PRODUCT SERVICE BULLETIN

Safety report bulletin PS 04202012

***RESERVE LOWER STEERING LINES
AND
RESERVE TOGGLES***

Subject: Reserve lower steering lines and reserve toggles.

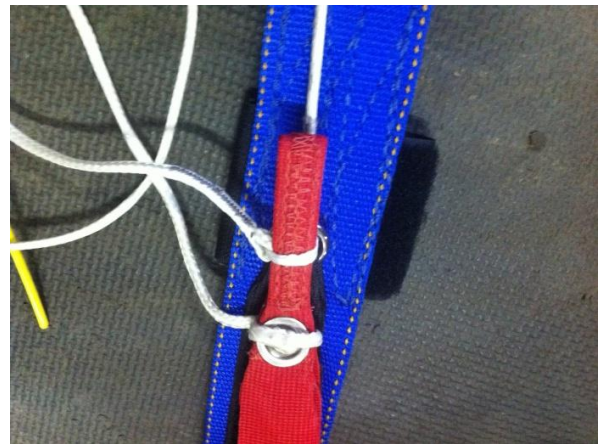
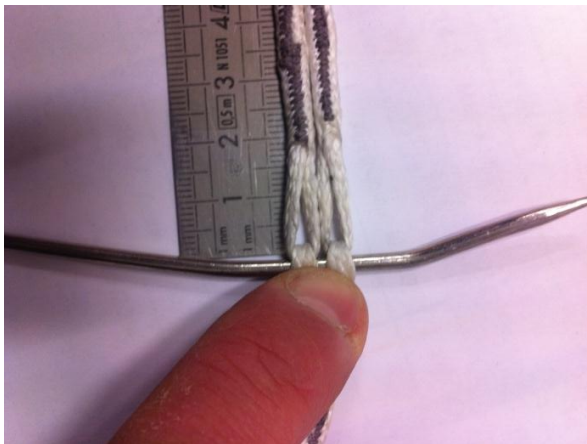
Background: Right reserve toggle locked after a cutaway procedure generating 2 rapid turns.
April 13, 2012 (Gap, France)

1. Bartack sewing on the right lower steering line is too close to the brake set loop (5mm or 3/16" less than the left one)
2. Toggles nozzle are too soft, implying a nozzle narrowing.
